# **MIPS R4400PC/SC Errata, Processor Revision 2.0 & 3.0**

January 24, 1995

Figure 1a: Power-on Reset or Cold Reset - Workaround for Bug# 16

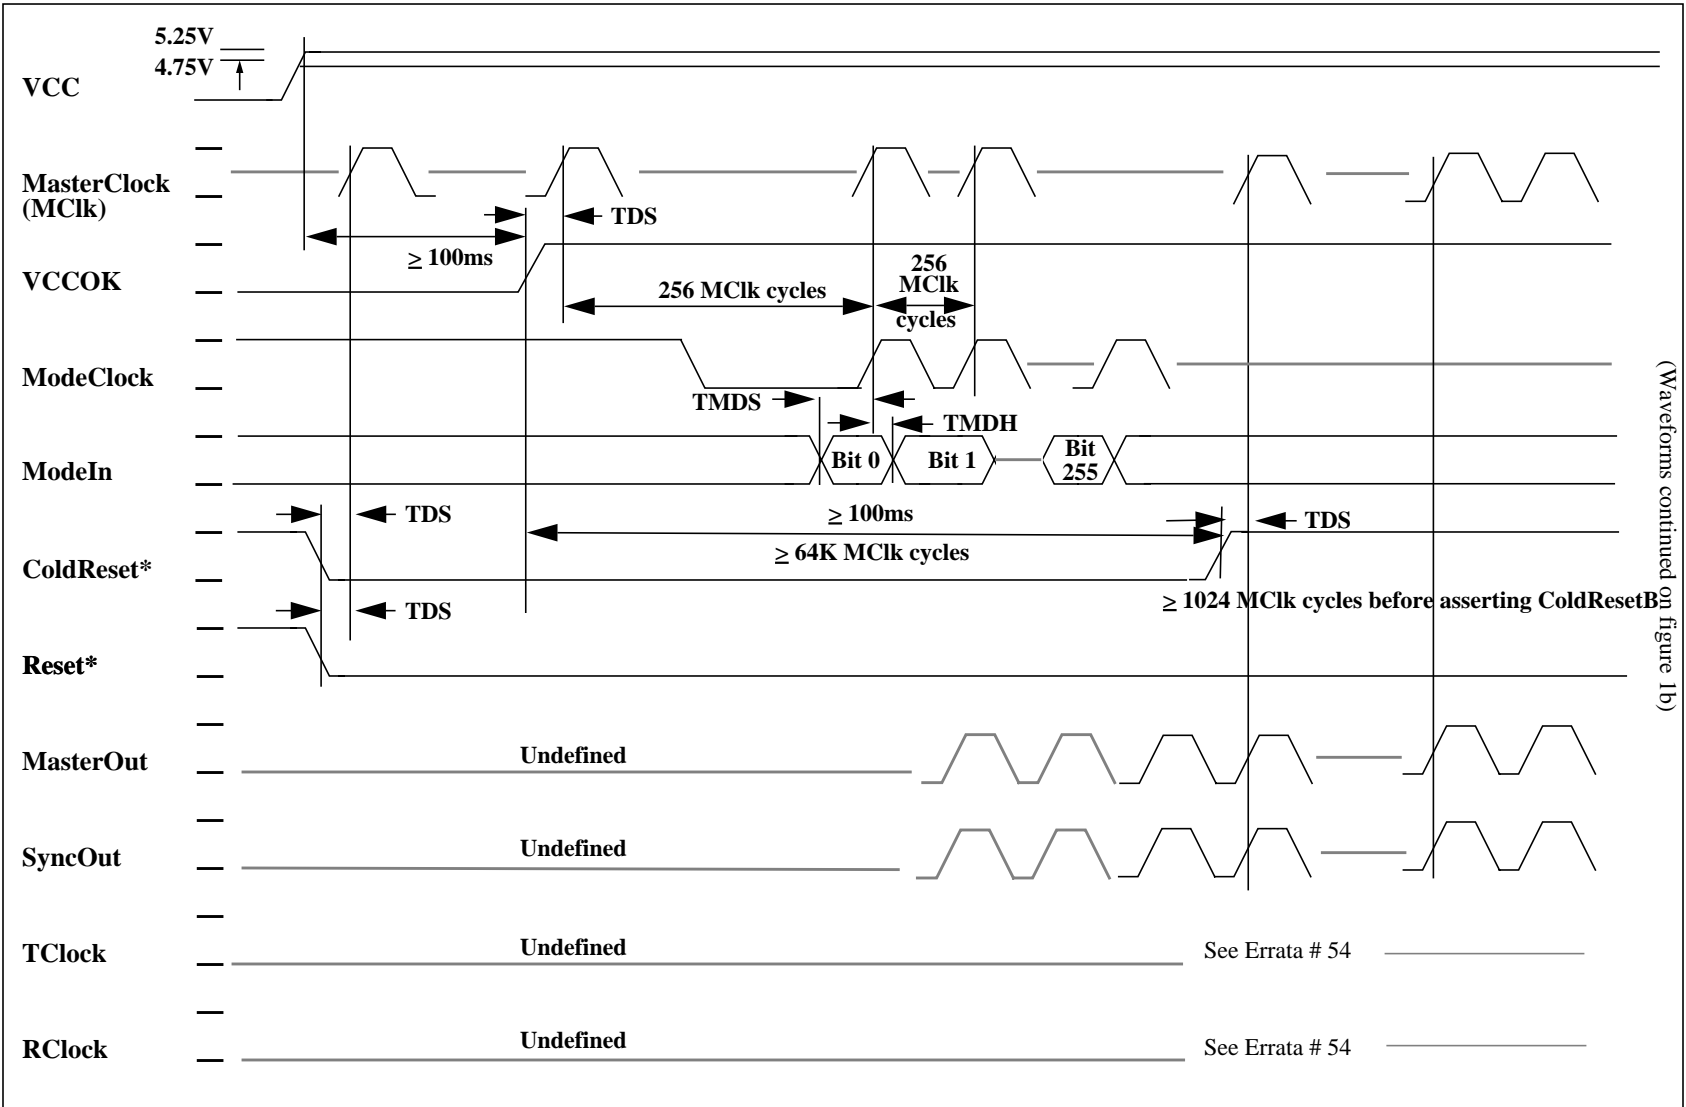
15. R4400PC, R4400SC: During the power up sequence, the period of TClk and RClk may not be as expected for at least 1024 MasterClock cycles following the de-assertion of ColdResetB. The above bug is true for all system interface divisors. Furthermore, if the system interface divisor other than 2 (i.e. 3,4,6 & 8) is used, TClk and RClk's rising edge may not align to the rising edge of the MasterClock, as specified.

**Workaround:** Assert a second ColdResetB after at least 1024 MasterClock cycles from the de-assertion of the first ColdResetB. ResetB should remain asserted until at least 64 MasterClock cycles following the de-assertion of the second ColdResetB. TClk and RClk will then be valid 64 MasterClock cycles after the de-assertion of the second ColdResetB and their edge alignment with respect to MasterClock will be as specified. Figure 1a & 1b show the waveforms in more detail. Note that the waveforms in Figure 1b are continuation of the those in figure 1a.
